REPLACEMENT OF MYNY SEAT LOCKS ON ALL NO. 5, 12, 16, HY-5, AND HY-5-II BIG ELI WHEELS

HY-5 BULLETIN

SUBJECT: REPLACEMENT FOR HANDYMAN JACK

Subject: Bolt Wear in HY-5 Spoke Stack Tenon Chain

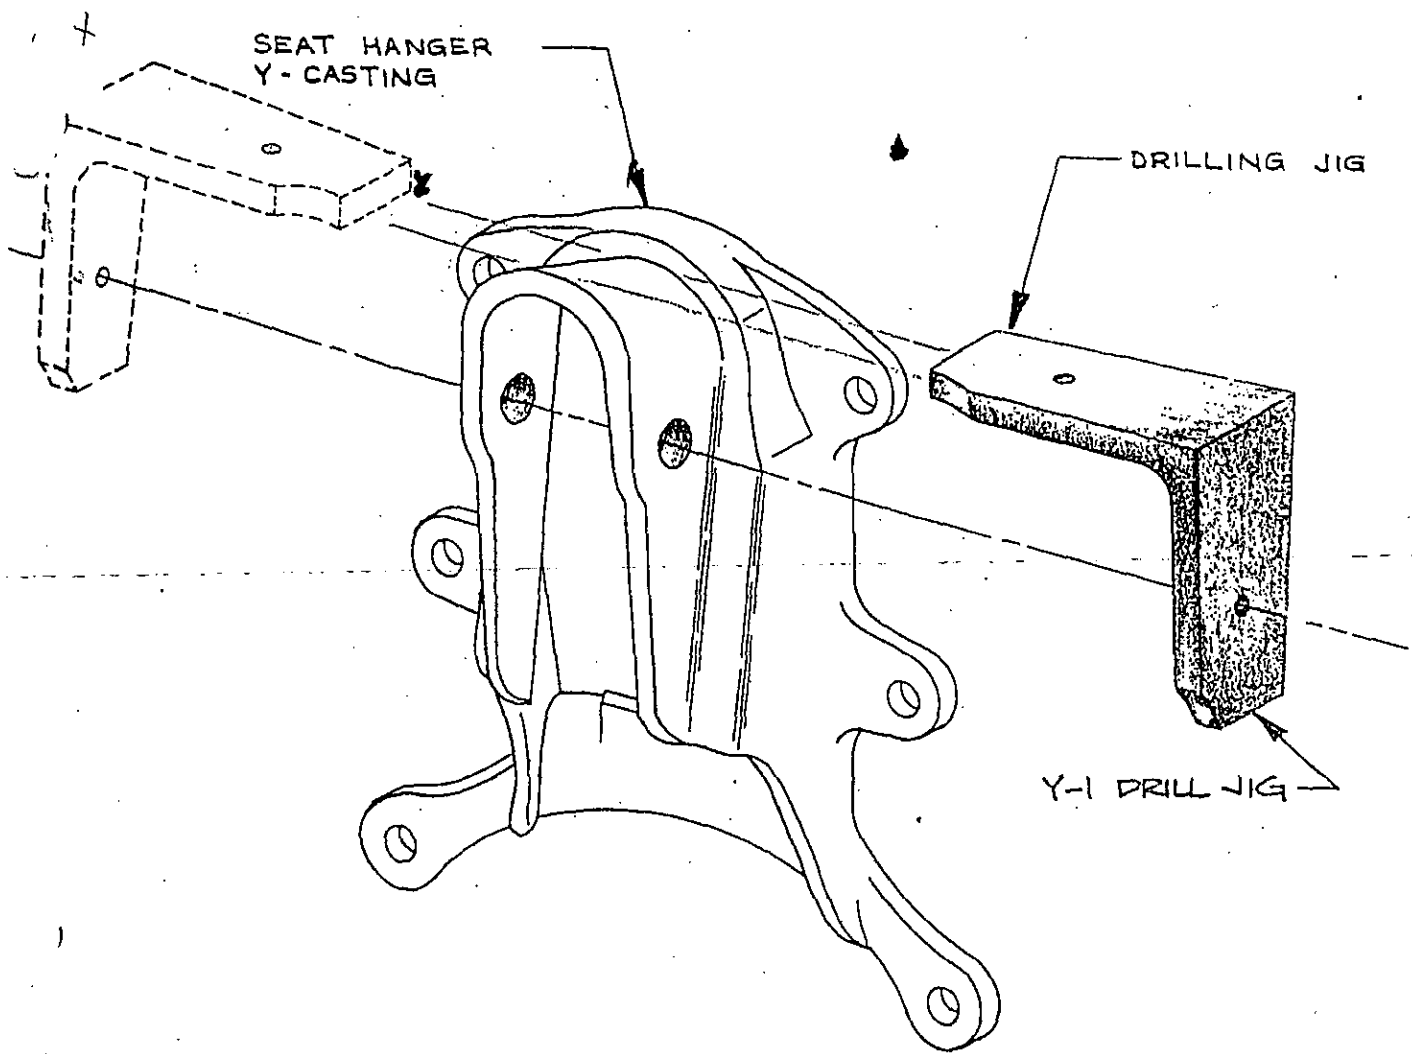
We feel that for safety considerations it is very important for the operator to be sure that each seat pin is properly locked, and so we are now furnishing the No. 425-430 pin and 3/16" Klik-pin in place of the MYNY seat lock. The operator must look at the pin in order to be able to insert the Klik-pin, and in doing so he will see whether or not the seat pin is securely locked.

Modifying the seat hanger casting is easy. You are provided with a drilling jig which is shown in the sketch. Lay the drill jig on top of the seat hanger casting, with the cutout corner located as shown. Drill a $3/16$ " diameter hole through one side of the casting, using the drilling jig as a guide for the drill. Then roll the drill over the top and against the other side of the seat hanger casting. Drill a $3/16$ " hole through that side. The two sides of the casting are not parallel, so the two holes are not exactly in line with each other. Drill clear through both sides of the casting with a $1/4$ " diameter drill to straighten the two holes into alignment, and follow with larger drills until the final hole size is $33/64$ " diameter, which is $1/64$ " larger than pin diameter.

RE: Loading Platform Pinch Cover.

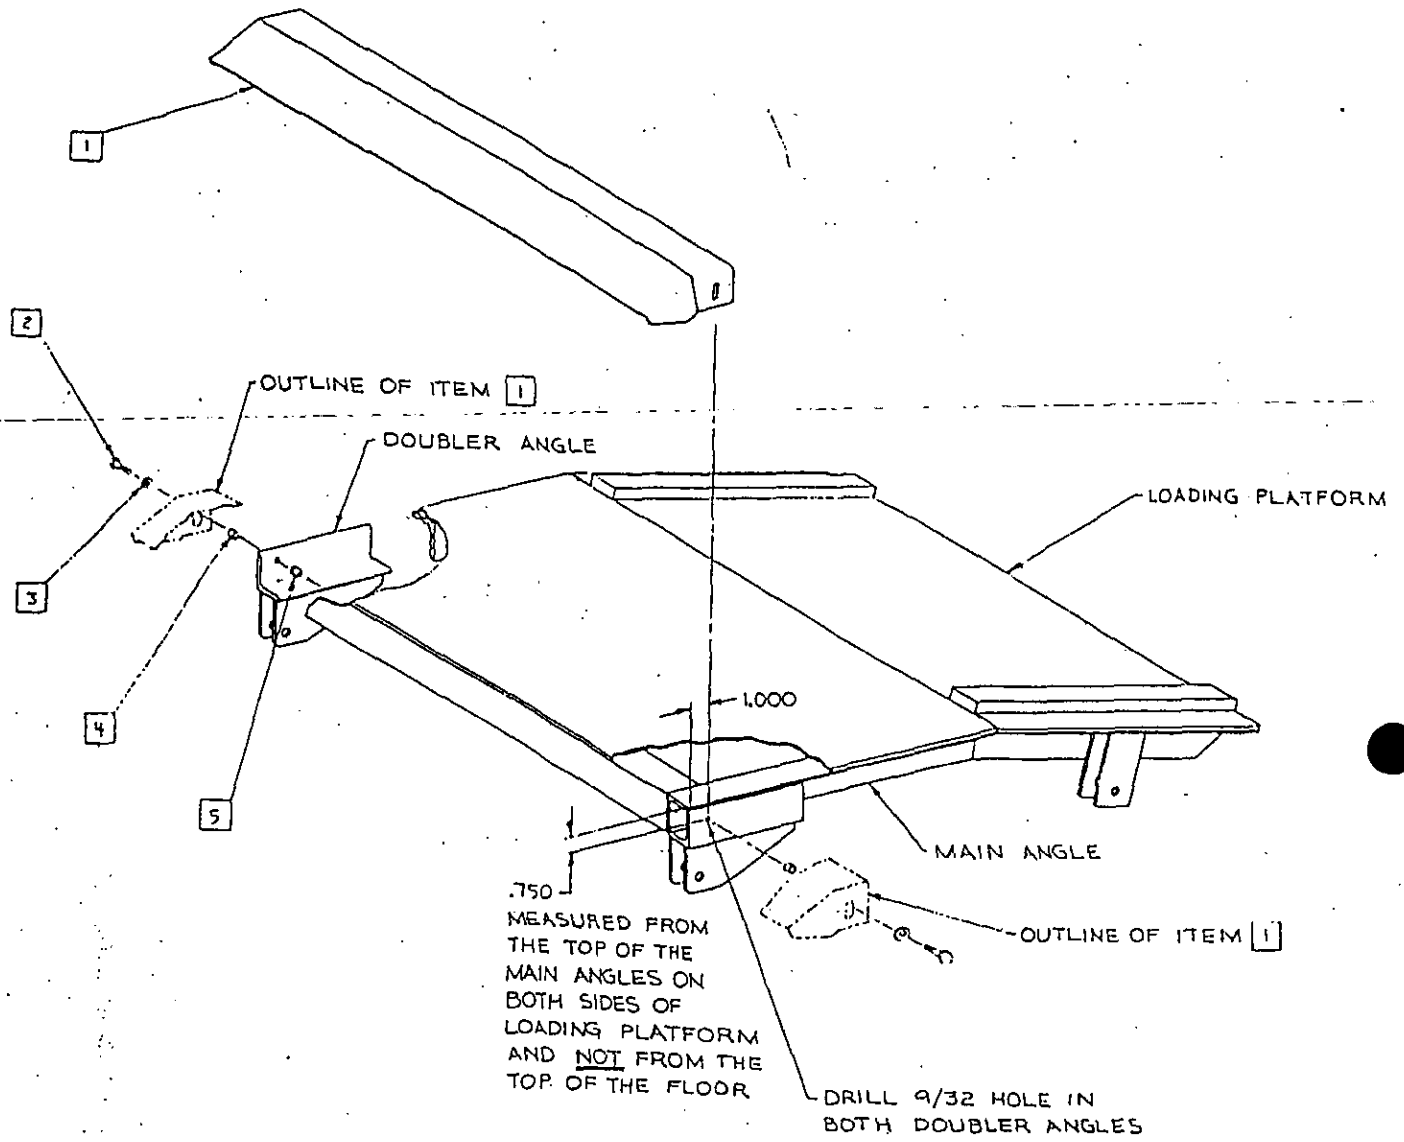
In an effort to prevent future incidents which can only occur by misuse, the accompanying cover is being furnished to you to install on your HY-5 BIG ELI Wheel. Please read and follow the instructions carefully.

1. Drill a 9/32 hole in the doubler angle, one each side of the loading platform, one inch horizontally from the rear end of the platform, and 3/4 inch vertically from the top of the main angle (refer to drawing).
2. Set the pinch cover over the gap with the long side to the rear of the trailer.
3. Bolt the cover on so that the spacer is in the slot and the washer holds the cover on the spacer. The bolt should be tightened so the spacer is solid against the angle.
4. The cover should have some play in it to allow it to follow the contour of the ramp. If the cover is not free to move, check to see that the cover is not caught between the spacer and the angle, or the spacer and the washer. If this does not work, file out the slot until it is free.
5. To work properly all edges of the cover must be flush with the platform and ramp, otherwise the cover will become a trip hazard.

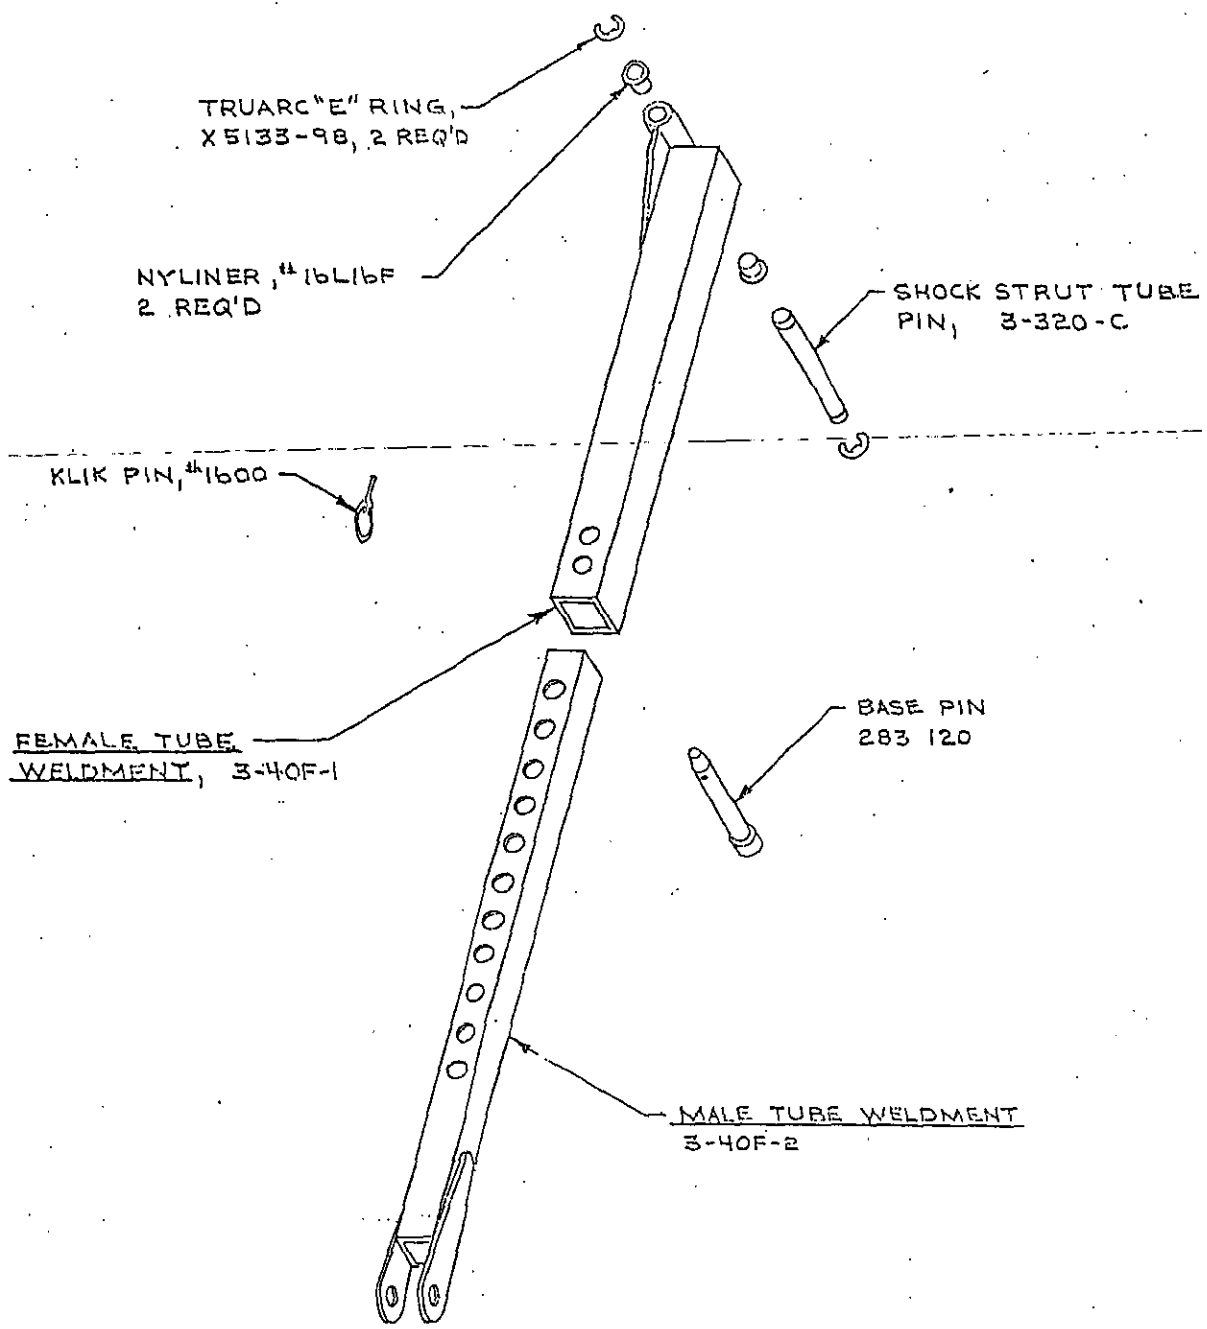
There have been a few instances where the handyman jack, used to apply tension to the idler pullback rods, has broken. When this happens, drive cable tension is lost, along with control of the Wheel.

We are sending this replacement for the handyman jack at no charge. It is to be installed in the same location as the handyman jack was.

The series of holes will allow you to pin the two parts together so that very little tightening will have to be done on the idler pullback turnbuckles. Install the No. 283 120 base pin and lock it with a Klik-pin.

DATE 30 MAY 79			SCALE 1=10	JOB HY-5	ORIG. EQUIP. 54 THRU-
DES EJS	DRN LADRLY		TITLE JACK ASSEMBLY		
CHK VJ	APPR VJ				
MATERIAL			NUMBER OF PARTS REQ'D 1	PART NUMBER 3-40F

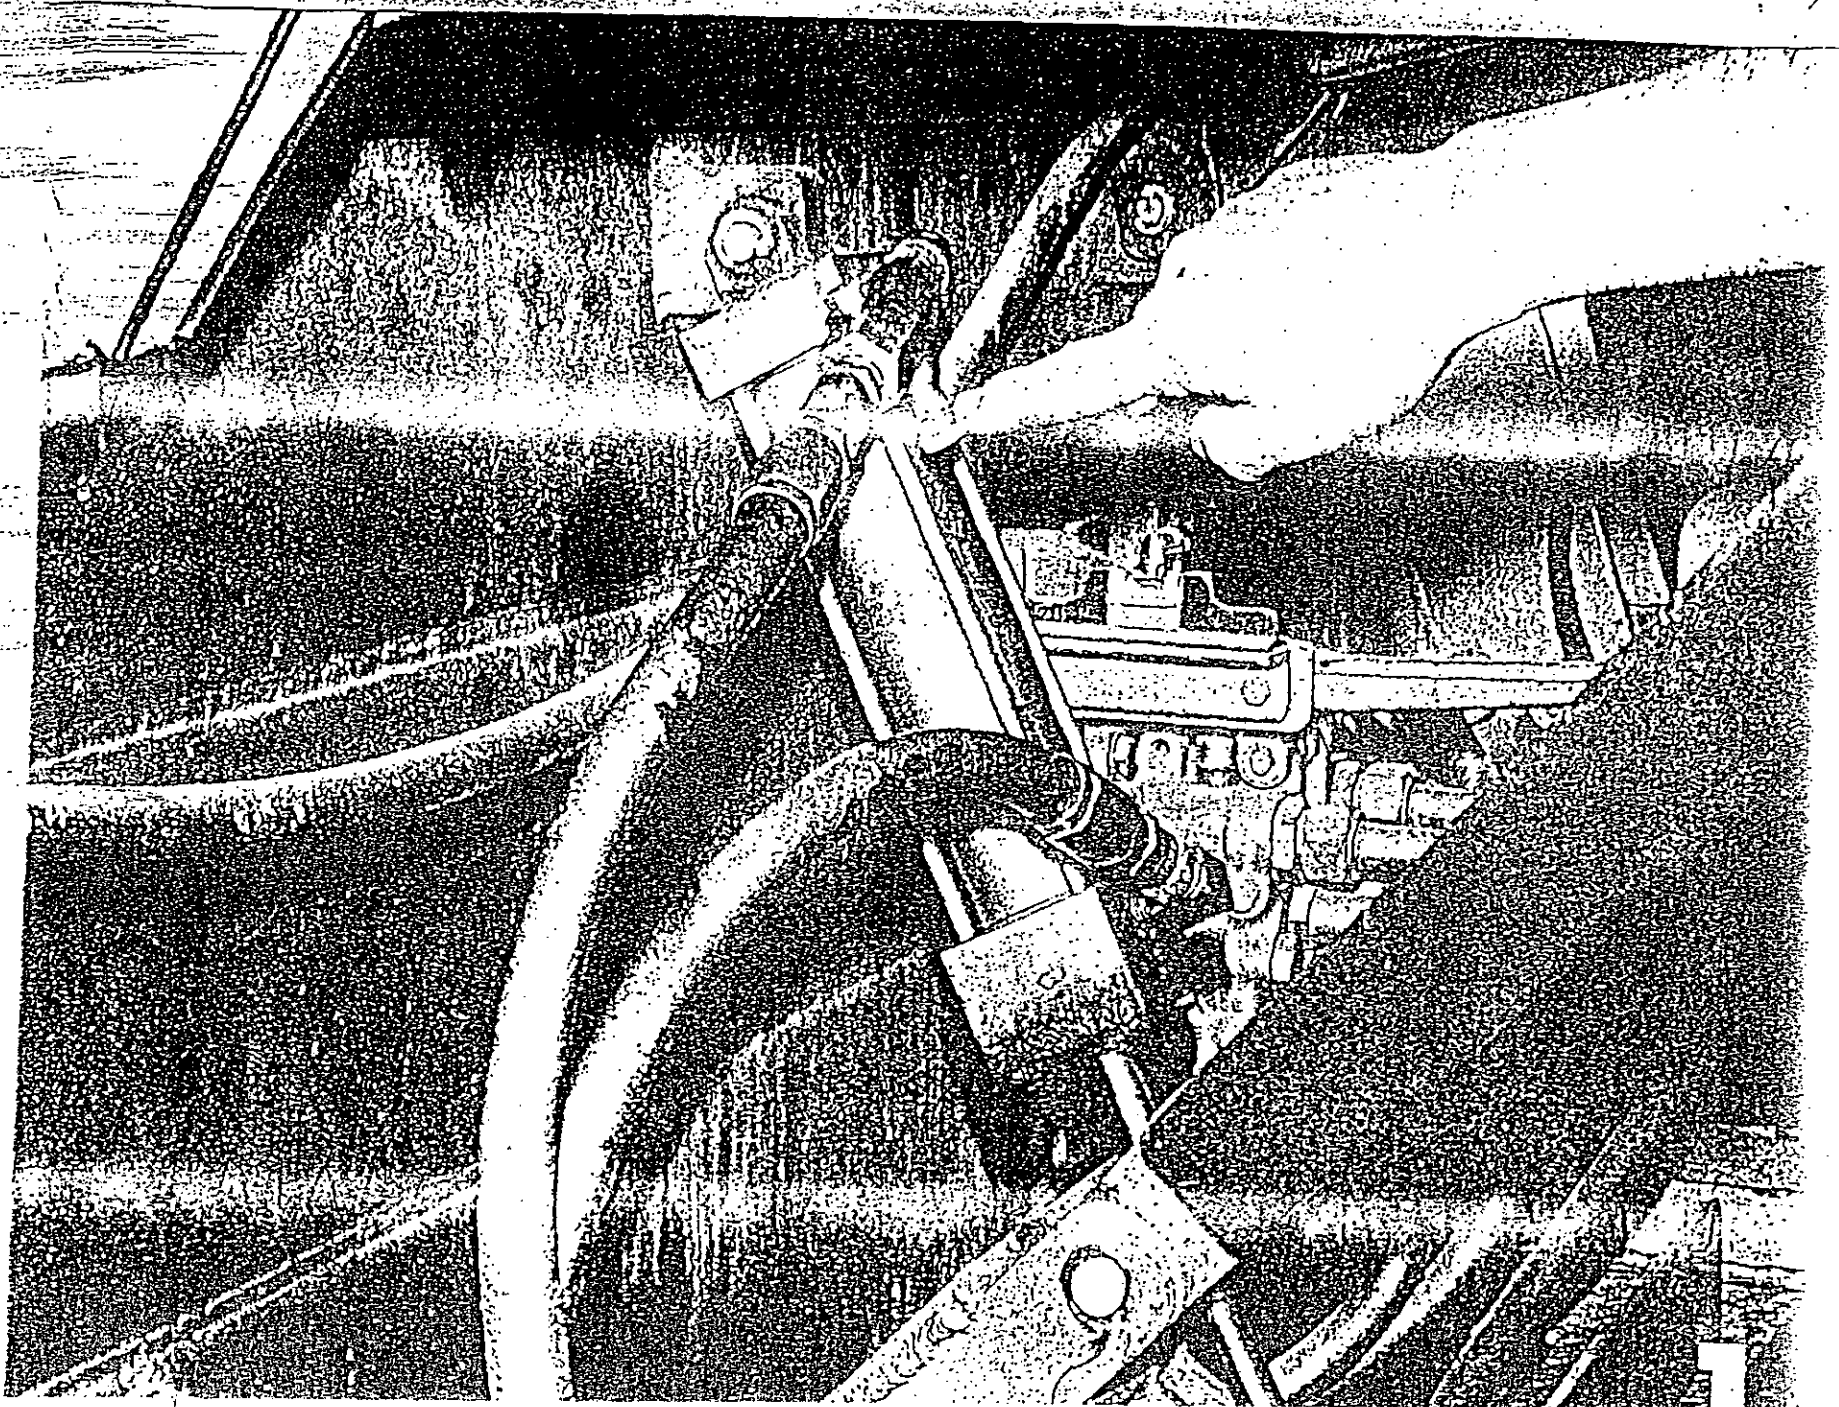
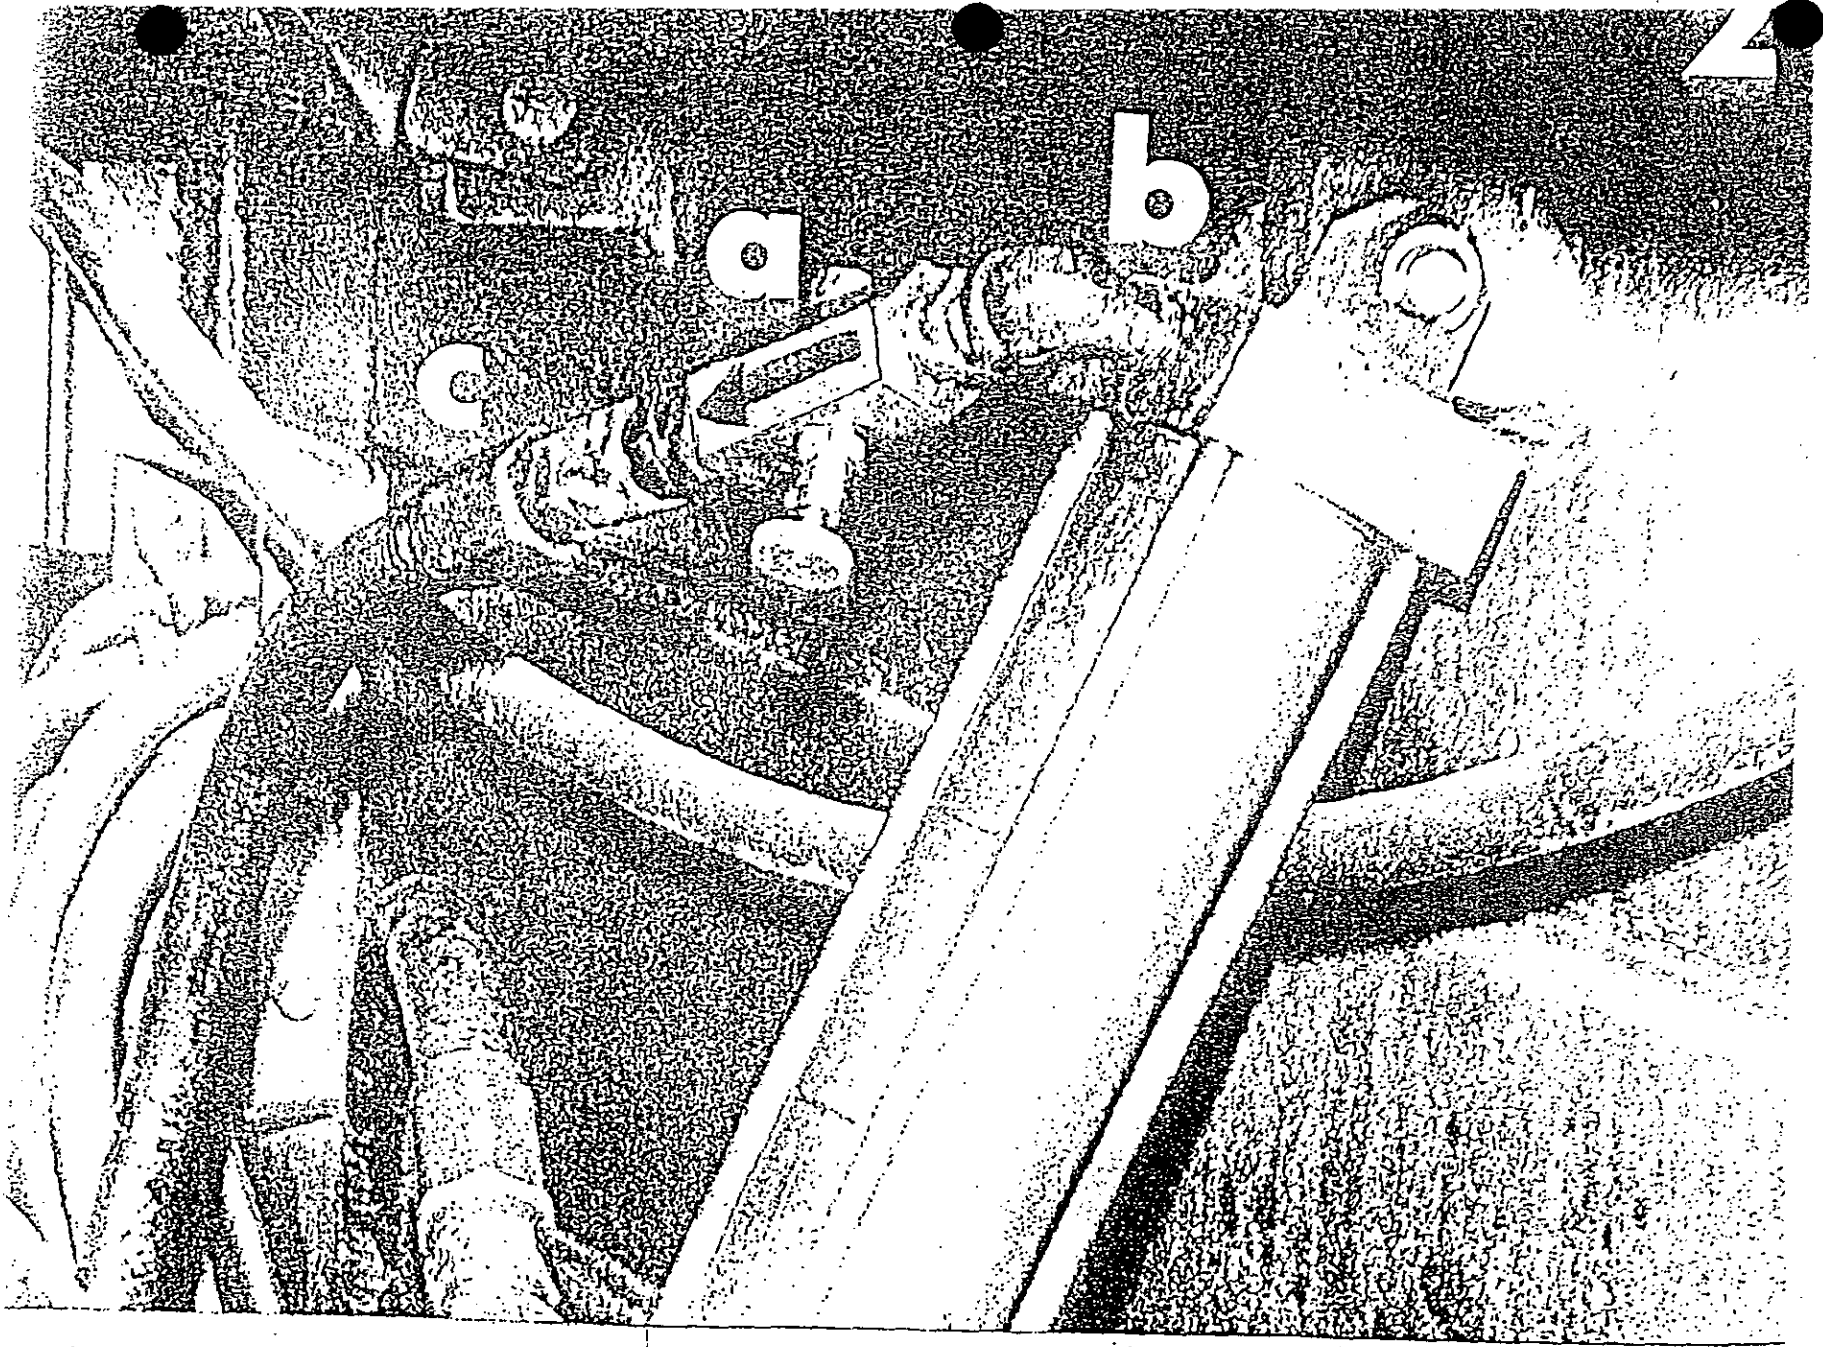
An improved Pullback Adjustment Assembly has been developed to replace the handyman jack arrangement. It is very simple to install. We are prepared to send you this new style assembly WITHOUT CHARGE, f.o.b. our factory.
